ADDENDUM No. Four (4)

IFB No. 2021-239

CONSTRUCTION, COLLIN COUNTY ADULT DETENTION FACILITY, PHASE 1 ADDITION

DATE: AUGUST 20, 2021

FM: FIRE PROTECTION STANDARD COMMENTS

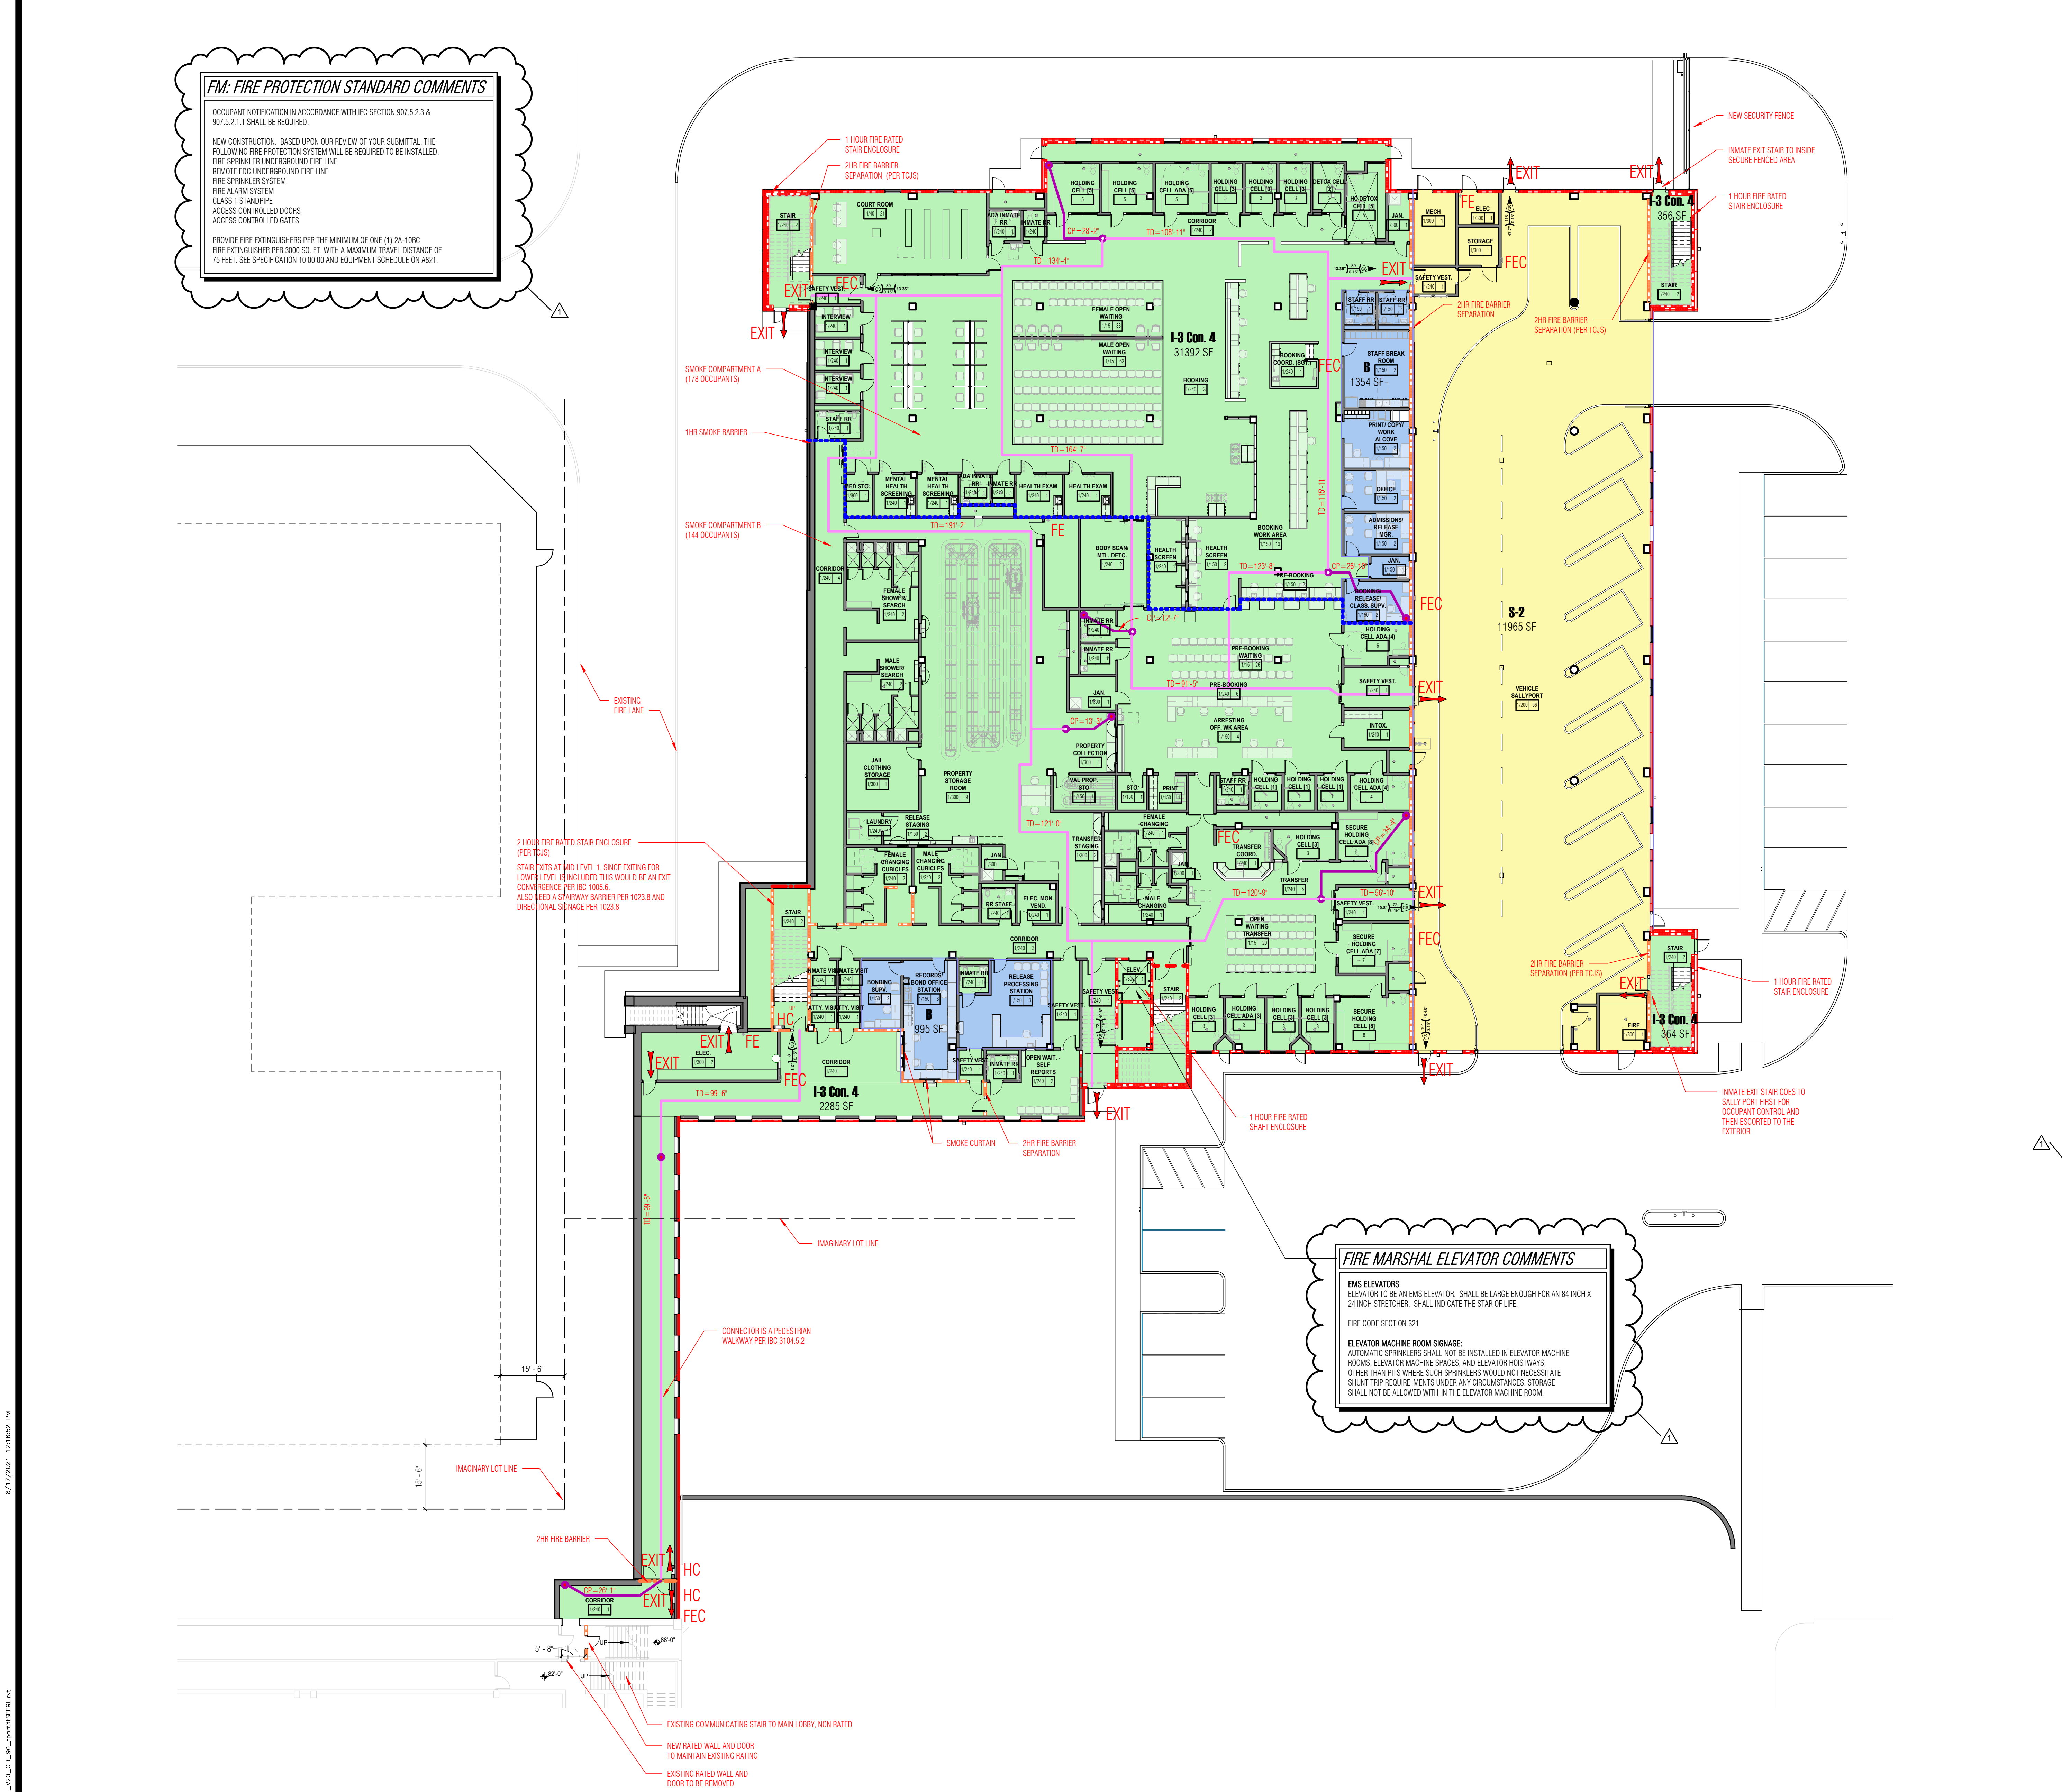
A. Window protection note updated.
B. Fire Marshal fire protection standard comments and elevator comments added.
- Item No. 27. Sheet – A020, A021, A022**

21913
07/13/2021 A201

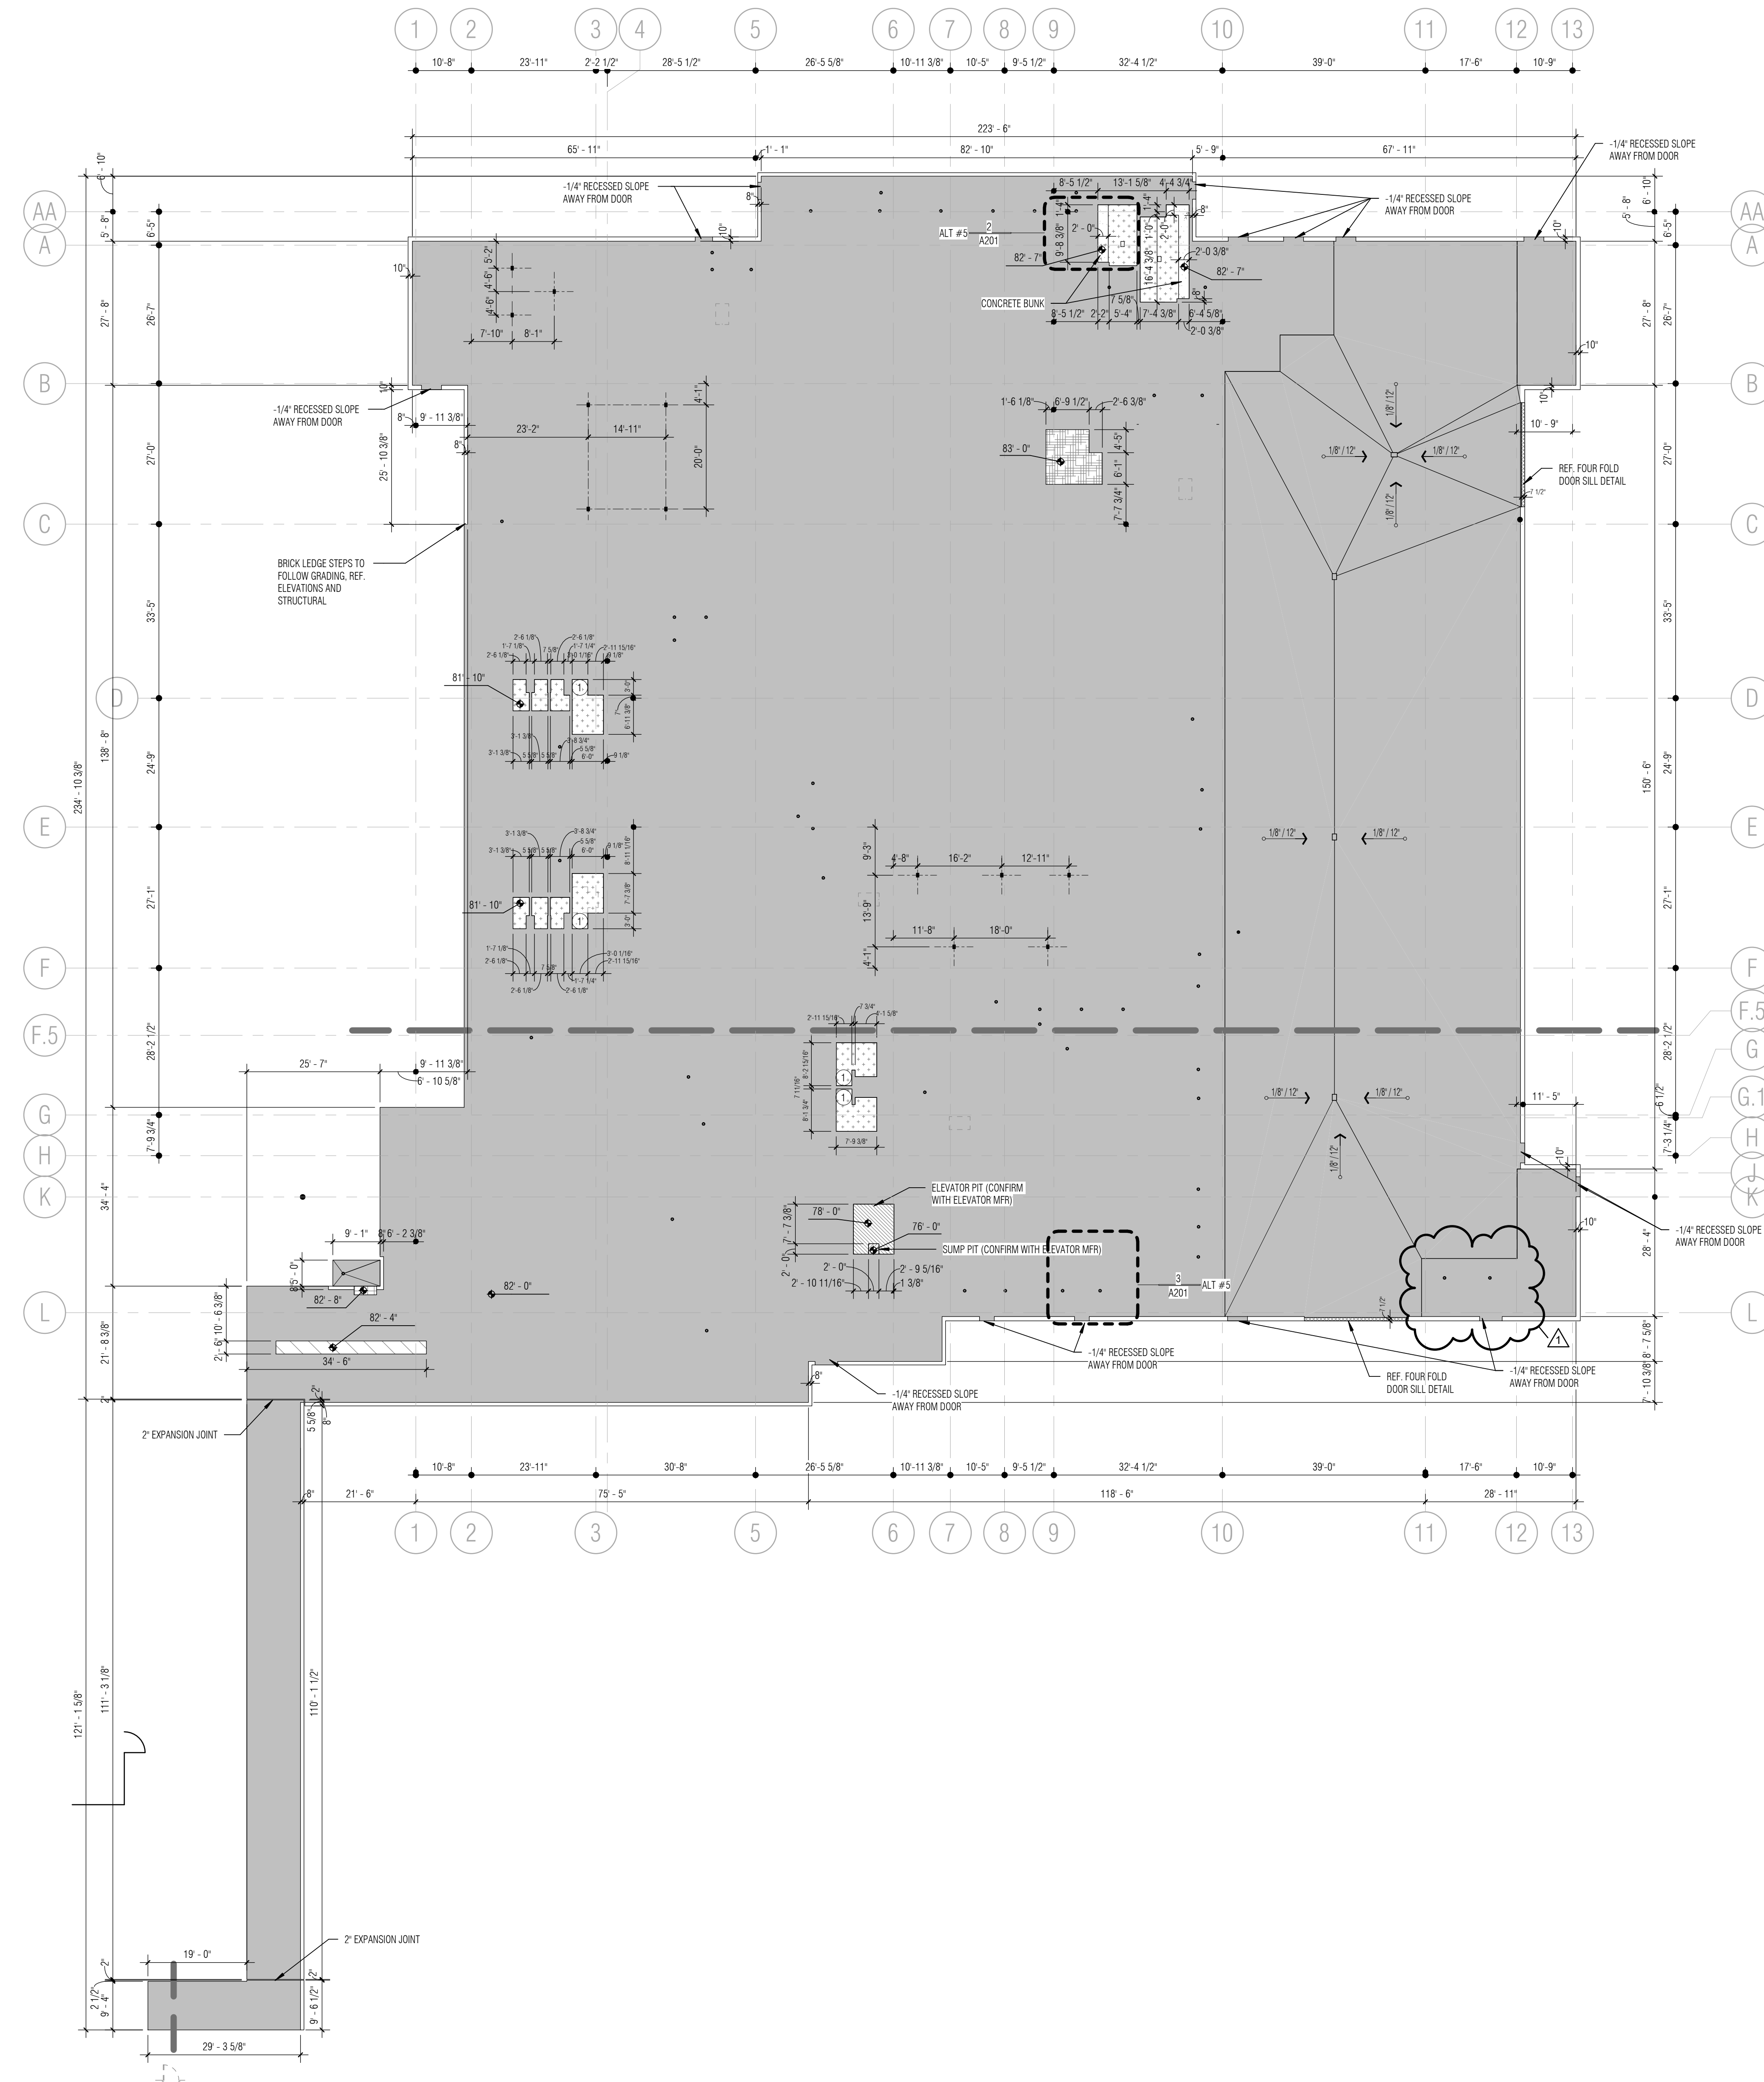
A. Window protection note updated.
- Item No. 28. Sheet – A201, A210, A222, A223, A281**
A. Updated plan at fire room door.
- Item No. 29. Sheet – A411**
A. Updated finish note and fire door.

21913
E201
7/13/2021

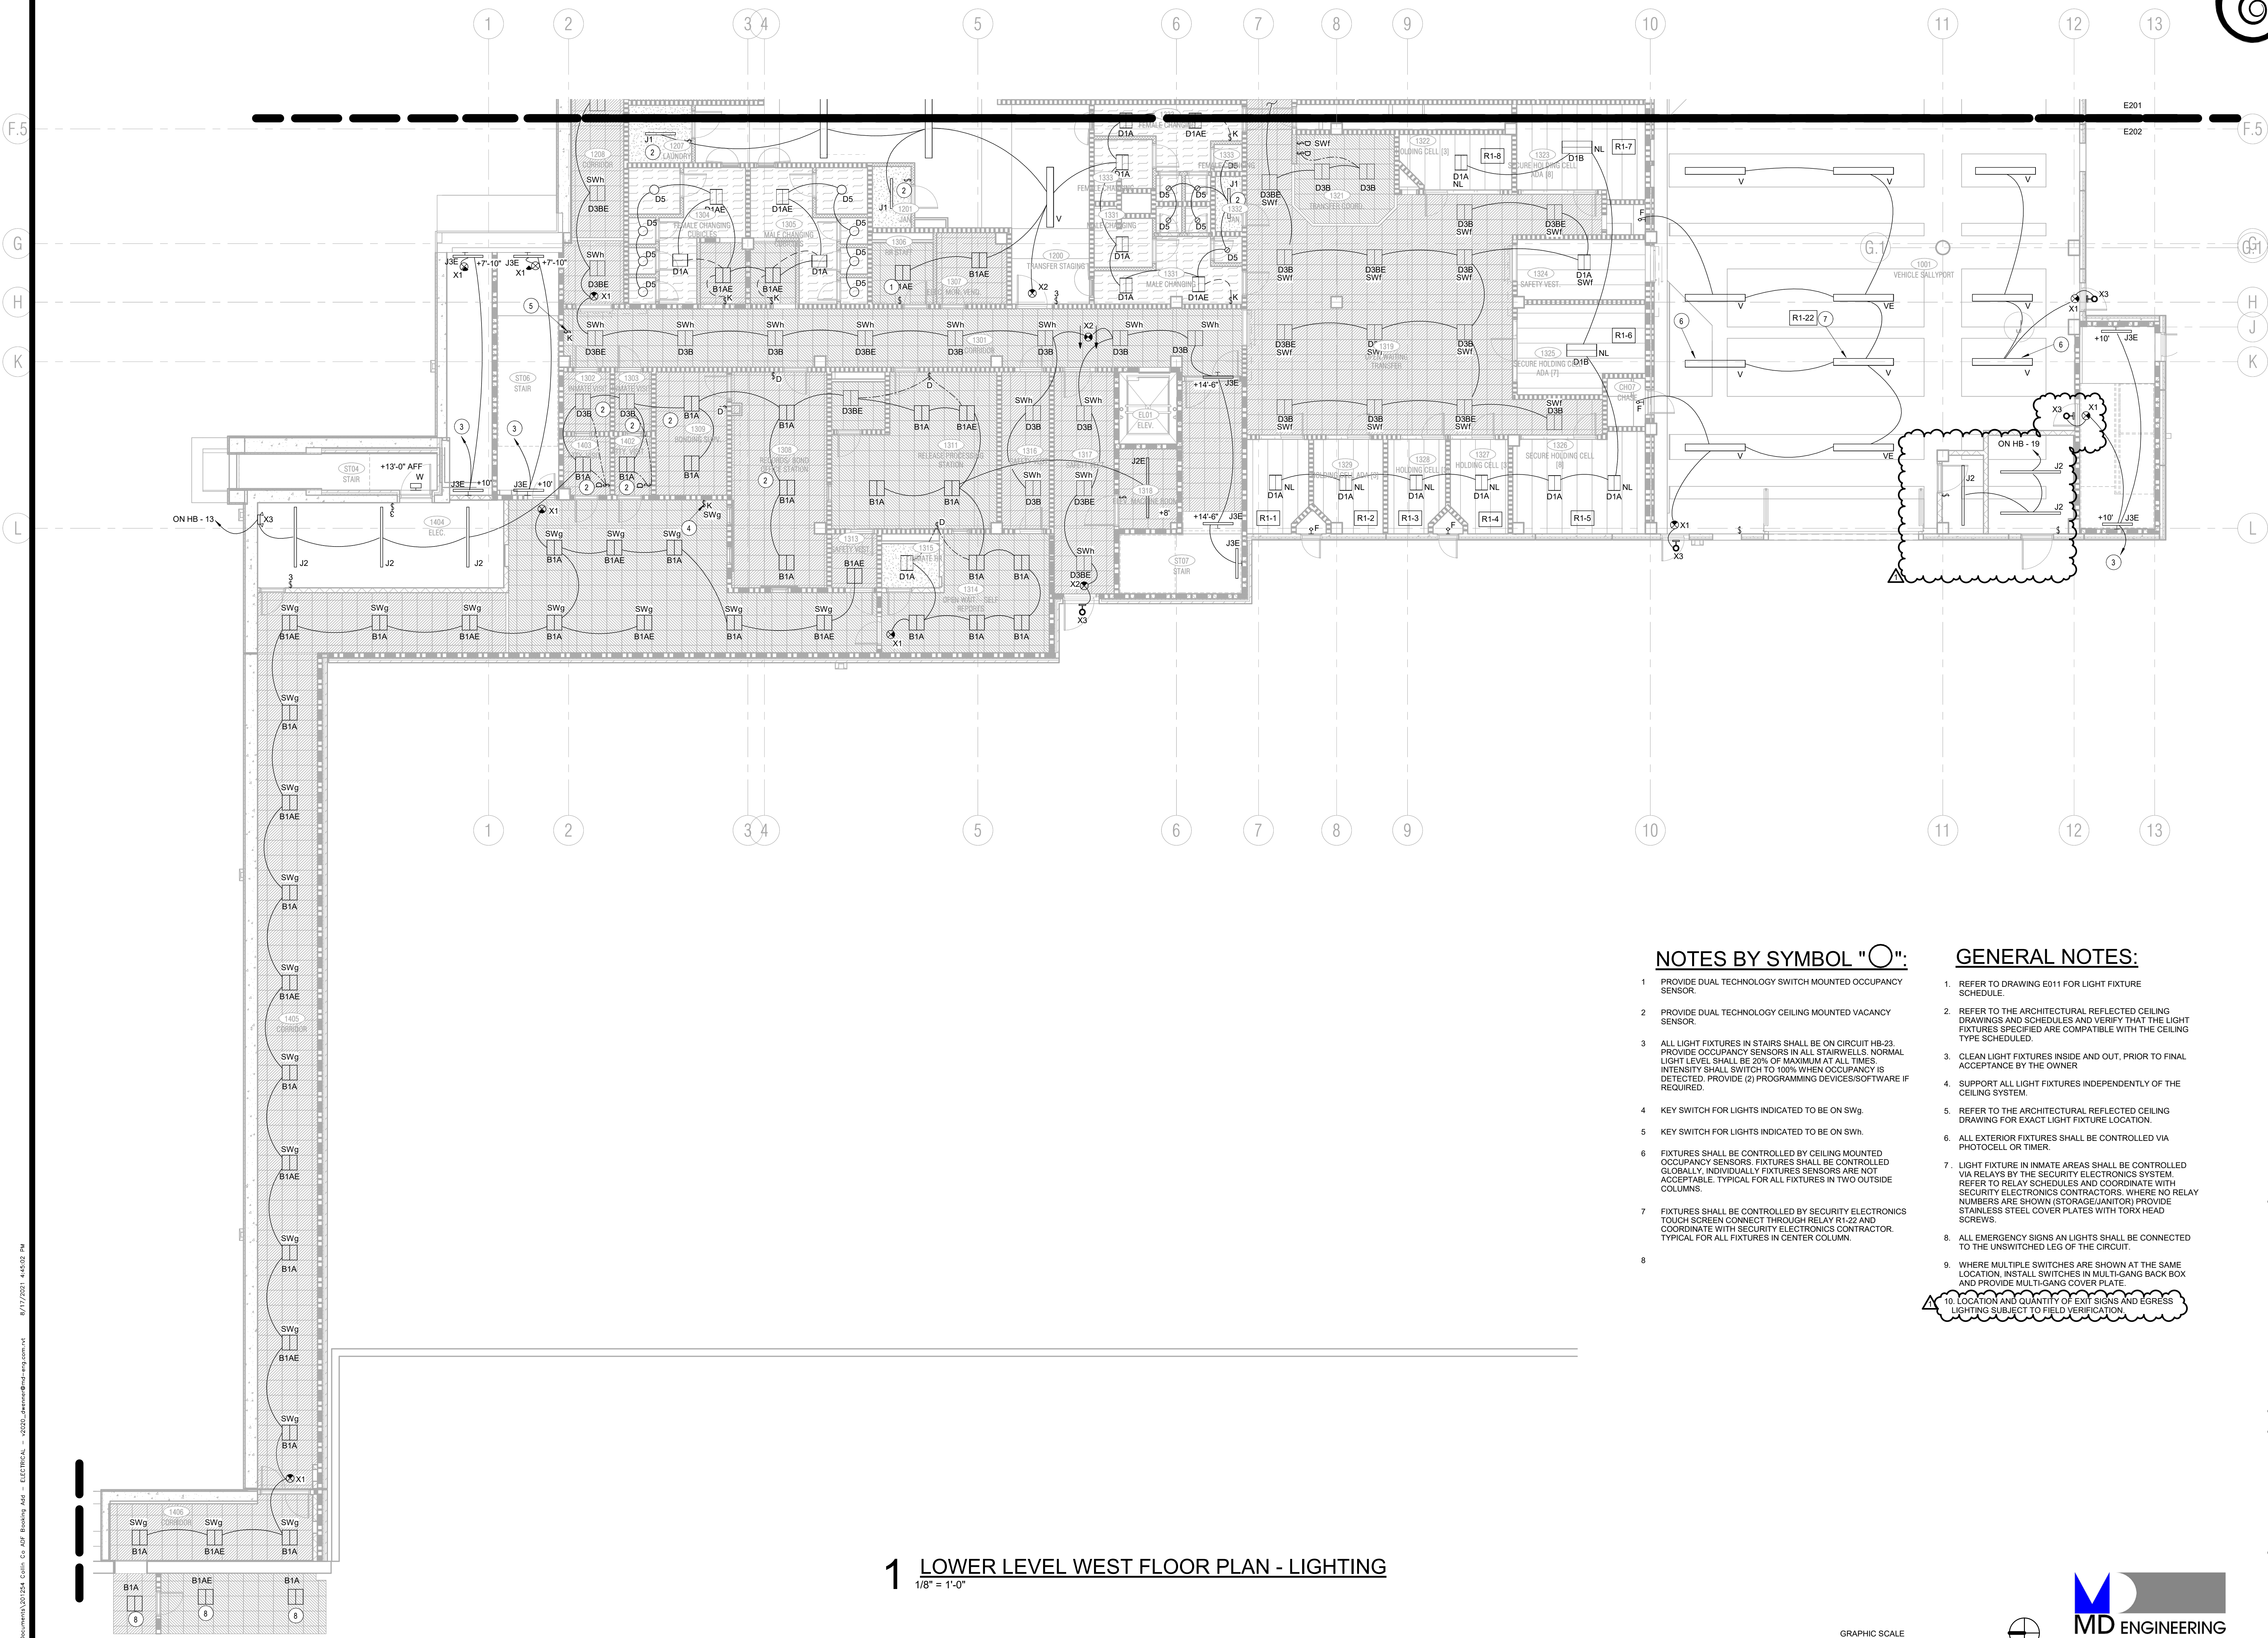
A. MDE Revision: General note added.
- Item No. 63. Sheet – E221**
A. MDE Revision: Moved light fixture in mechanical room corridor to wall.
- Item No. 64. Sheet – E302**
